Proposal #25: 1196-00-60
Minong – Solon Springs
CTH Y to CTH M (Sb)
USH 53
Douglas County

This is Addendum No. 01, which provides for the following:

ADDENDUM NO. 01

1196-00-60

PROJECT NO: 1196-00-60	HWY: USH 53	COUNTY: DOUGLAS	TRAFFIC CONTROL - TYPICAL SECTIONS	SHEET 30	E

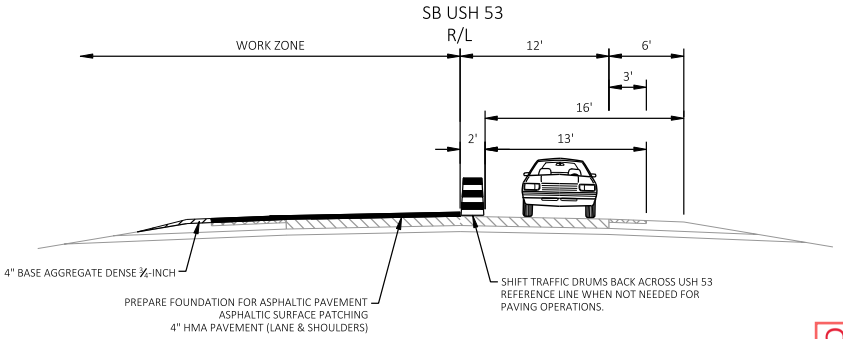
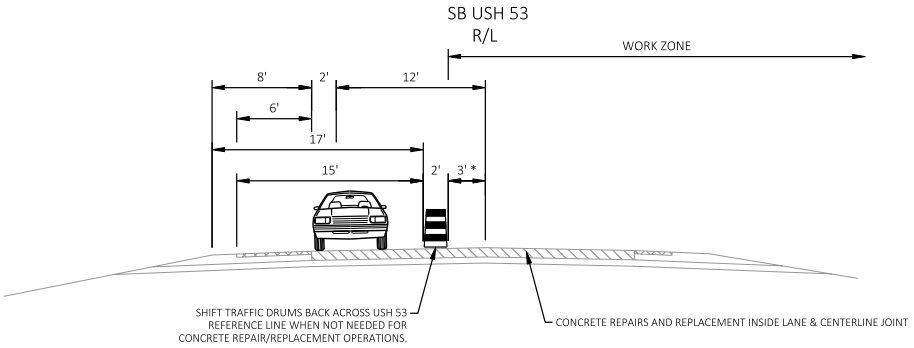
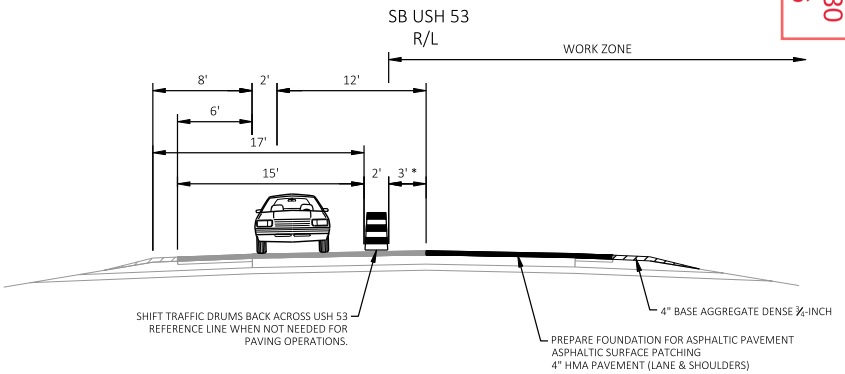
Revised Plan Sheets	
Plan Sheet	Plan Sheet Title (brief description of changes to sheet)
30	Traffic Control – Typical Sections (add notes to Stage 3A and Stage 3B to clarify binder on both lanes can be placed prior to surface)
42	Miscellaneous Quantities (update the Drilled Tie Bars, Drilled Dowel Bars, Special Concrete Pavement Repair Doweled, Special Concrete Pavement Replacement Doweled and Special Concrete Pavement Centerline Joint Repair quantities table)
43	Miscellaneous Quantities (update the mixture acceptance and density acceptance columns)
47	Miscellaneous Quantities (update the Sawing Asphalt and Sawing Concrete quantities table)
48 – 55	Plan over Plan Sheet (update Special Concrete Pavement Repair Doweled, Special Concrete Pavement Replacement Doweled and Special Concrete Pavement Centerline Joint Repair areas)

* NOTE
- 0' TYP
- UP TO 3' FOR CENTERLINE JOINT REPAIR

* NOTE
- 0' TYP
- UP TO 3' FOR CENTERLINE JOINT REPAIR
